Access Compliance Report

Public Rights-of-Way

Intersection ID: 13540	Main Street: LEXINGTON_AV	Cross Street: S_CALDWELL_ST	Location: W
ADA ID: 5A13C2A75B27	Ramp Type: PerpDiag	Initial Pass/Fail: Fail	Overall Compliance: No
			Severity Score: 13.75

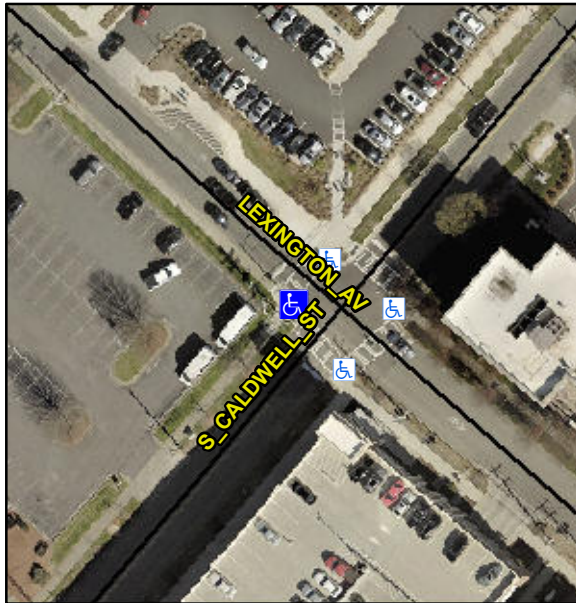
R304.2.2, R304.5.3

Compliance	Description	Data	Compliance	Description	Data
N/A	Ramp Length (in)	51.0	No	Ramp Slope (%)	10.0
Yes	Ramp Width (in)	72.0	No	Ramp XSlope (%)	4.7
N/A	Flare Type LT	N/A	N/A	Flare Type RT	N/A
N/A	Flare Slope LT (%)	N/A	N/A	Flare Slope RT (%)	N/A
N/A	Flare Traversable LT?	N/A	N/A	Flare Traversable RT?	N/A
N/A	Landing Length (in)	N/A	N/A	DWS Provided?	N/A
N/A	Landing Width (in)	N/A	N/A	DWS Contrast?	N/A
N/A	Landing Slope (%)	N/A	N/A	DWS Length (in)	N/A
N/A	Landing X Slope (%)	N/A	N/A	DWS Full Width?	N/A
N/A	Landing Curb? (Y/N)	N/A	N/A	DWS Offset (in)	N/A
N/A	Shared Landing?	N/A			
N/A	Gutter Ponding?	N/A	N/A	Gutter Slope (%)	N/A
N/A	Gutter Lip Ht (in)	N/A	N/A	Gutter X Slope (%)	N/A
N/A	Painted X Walk1?	Yes	N/A	Painted X Walk2?	Yes
	X Walk 1 Direction	To SE		X Walk 2 Direction	To NE
N/A	X Walk 1 Width (in)	111.0	N/A	X Walk 2 Width (in)	77.0
	X Walk 1 Slope (%)	1.4		X Walk 2 Slope (%)	1.3
	X Walk 1 X Slope (%)	2.5		X Walk 2 X Slope (%)	4.2

Remove & Replace Curb Ramp With Two New Directional Ramps or Equivalent.
